**PLANNING COMMISSION SMART CODE REVIEW SUBCOMMITTEE MEETING**  
**Economic Community Development**  
**Blue Conference Room**  
**Wednesday, December 17, 2014**

**2. Thornwood Planned Unit Development, Northeast Corner of Germantown Rd. and Neshoba Rd. – Request Preliminary and Final Site Plan Approval of Phase 1**

Thornwood Development – Phases 4 & 5  
Germantown Road & Neshoba Road  
Germantown, TN 38138  
December 1, 2014  
Page 2 of 2

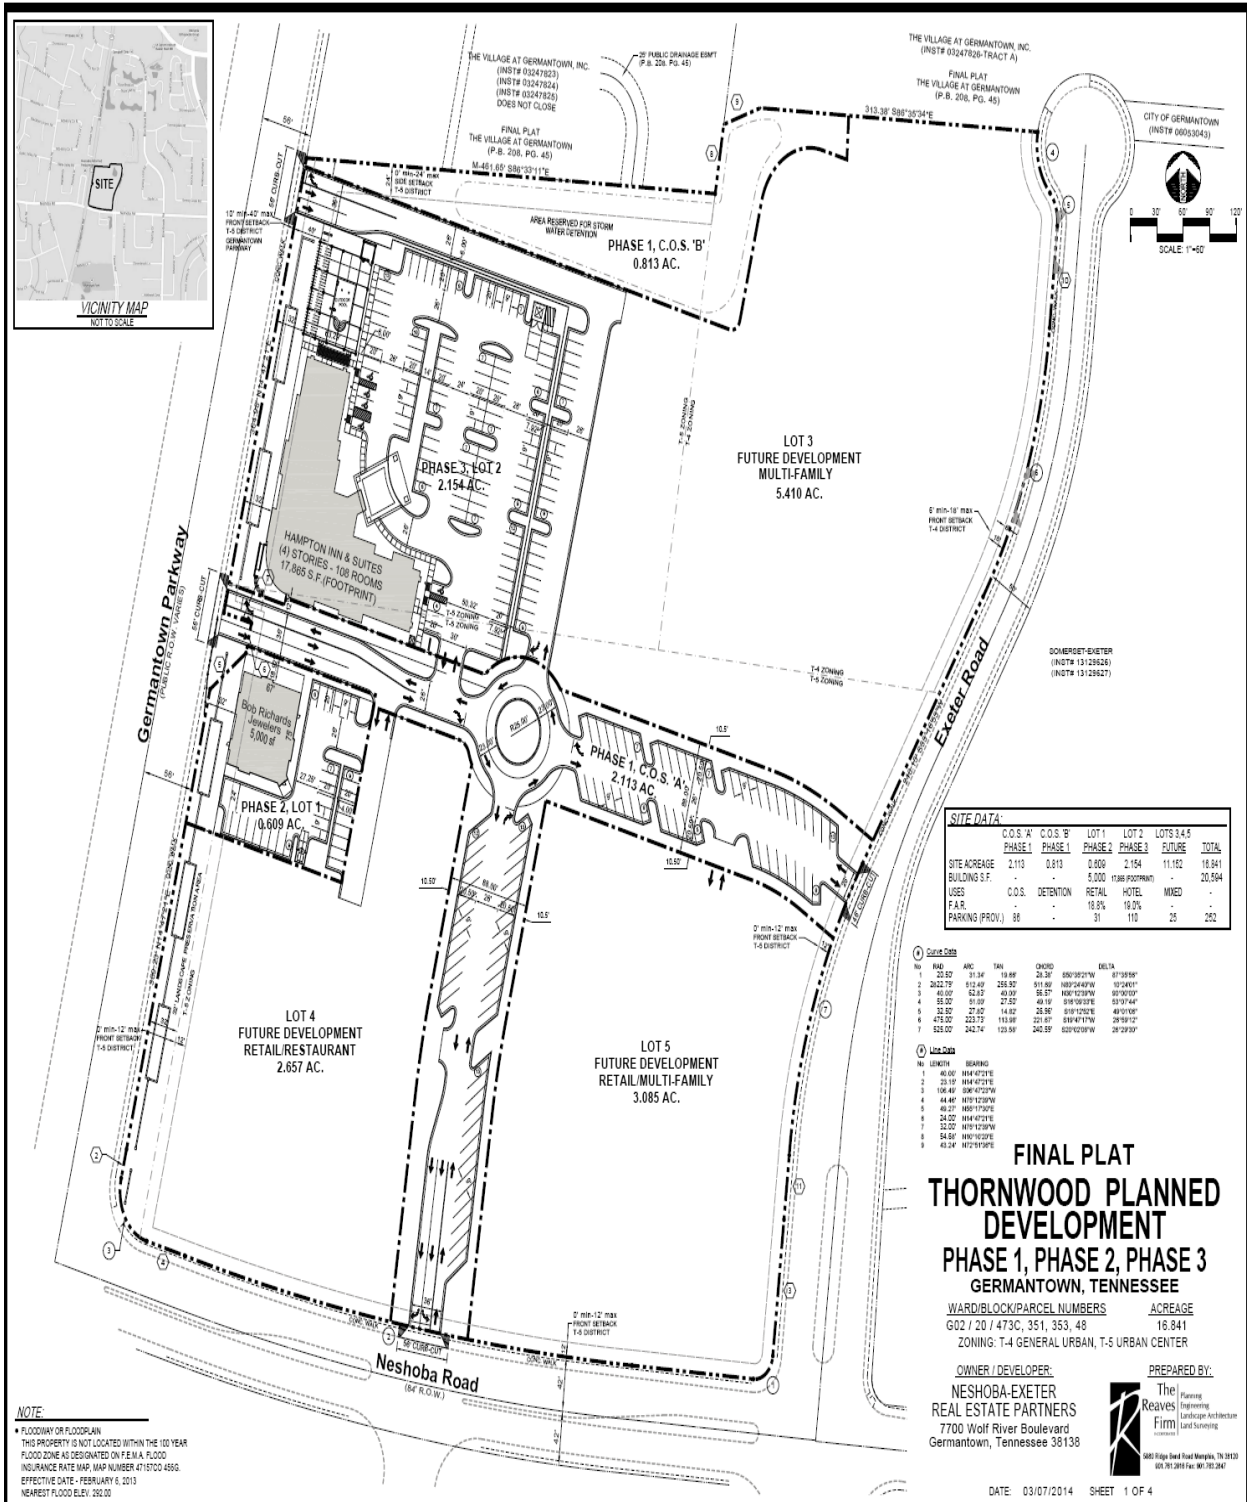
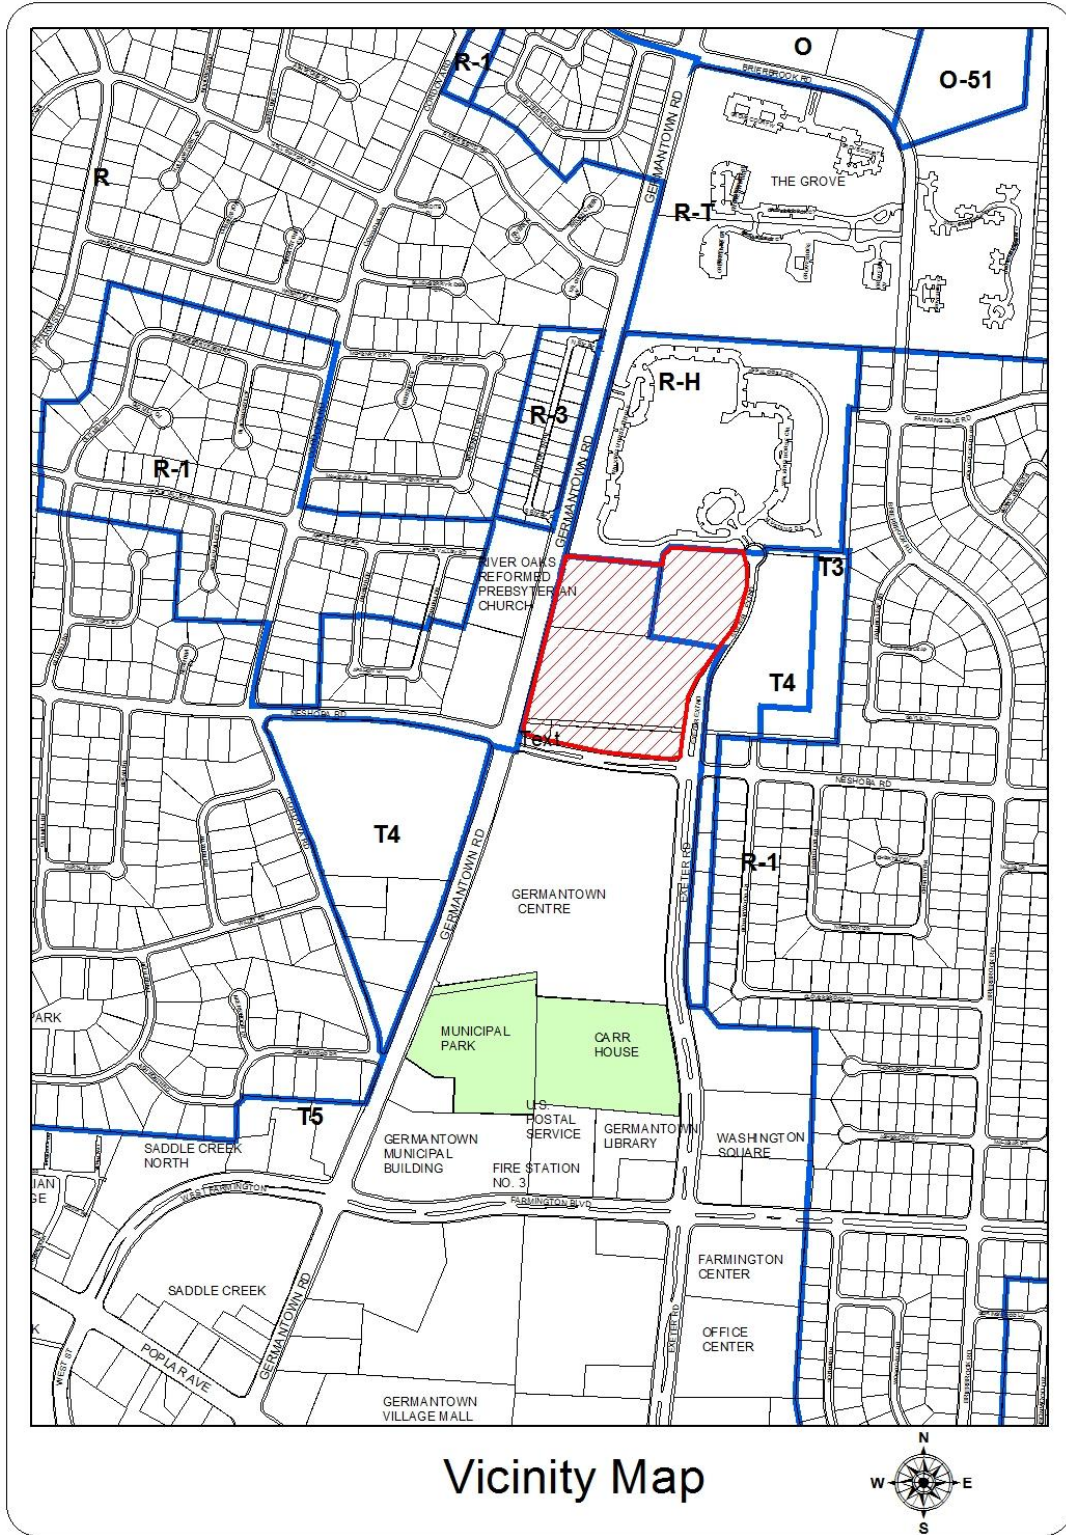
Per your request, the DRC members of the subcommittee has reviewed the revised elevations for both phases. Phase 5 is the apartment building located on the northeast corner of the development and consists of brick and limestone exterior within 5 stories. Phase 4 consist of retail and apartments located on the southwest corner and is a brick and limestone exterior within 3 stories. The reason for the review of the revised elevation was based on the request of the subcommittee that perhaps some variation in materials would help with the overall appearance of both buildings. The revised elevations presented by the applicant did in fact have changes to the variation of material placement, but no changes in type of materials requested to be used on the original submittal.

The member requested that in Phase 4 that the various between each retail store might be more like the vision of Smart Grow in the change from storefront to storefront as in an urban setting. The revised elevation only showed the change in brick to limestone and not changes to storefront in regard to windows, doors, etc. However, after reviewing Phase 4 changes, it was the opinion of the members that the sharp contract between colors of brick to limestone was not the desired variation that was being requested. After further review, the member recommend that the brick and limestone be used as submitted in the original elevations at the subcommittee meeting. Further, due to the fact that the elevation of the site does not allow street level entries into each retail store, the proposed concept for the building is the better one to use in this development. Therefore, it is the recommendation of the DRC members that brick and limestone placement shown on the elevations presented at the subcommittee meeting be the one used. Member recommend that further details of the sign band be provided in order to limit light emitting from either the top or bottom of the band from the halo lighting proposed of the signs.

Phase 5 was presented with brick and limestone for the exterior of the building. The request of the members was to see if variation in use of materials might be better in regard to appearance of the building. The applicant provided a revised elevation showing limestone being used at the balconies walls and below the windows that align with the balconies in lieu of brick. This does provide some change in the appearance of the building and was not totally objectionable, however, it was the opinion of the members that this may in fact make the building look too "busy". The limestone area below the balcony opening and that of the limestone below the windows were not of the same height and alignment. This was discussed with the applicant and asked if the balconies could be aligned with the top of the area below the windows to give a more symmetrical appearance. This would require that low height railing be placed on top of the balcony wall. However, this alignment, in the opinion of the members, would be more acceptable if the limestone was to be used. Further, the applicant changed the main entry elevation by adding limestone within the border of the original limestone detail. This was found to be very attractive and brought an elegant touch to the building. In summary of Phase 5 review, it is of the opinion of the members that the originally submitted elevations has be more elegant and sophisticated appearance than the revised. However, the members would like for the applicant to use the revised limestone entry elevation for the project.

Based on the materials samples presented by the applicant for both buildings, all materials were found to be acceptable in sustainability, color and texture for use on the exterior of these buildings in Phases 4 & 5. The proposed materials for the exterior for the proposed buildings work within the normal criteria by the Design Review Commission for commercial building outside the Smart Growth review. The proposed materials for both buildings are acceptable and recommend to the Planning Commission for approval for the proposed materials to be used on both buildings as submitted.

In summary, the elevations of both buildings work well with the prior two building approved for Phase 2 & 3, ie, Hampton Inns & Suites and Bob Richards Jewelry. The overall concept of the development is one that will be a strong northern anchor for the Smart Growth future development to the south. The applicant has presented buildings that have long life and are sustainable, along with elegance and practicability.
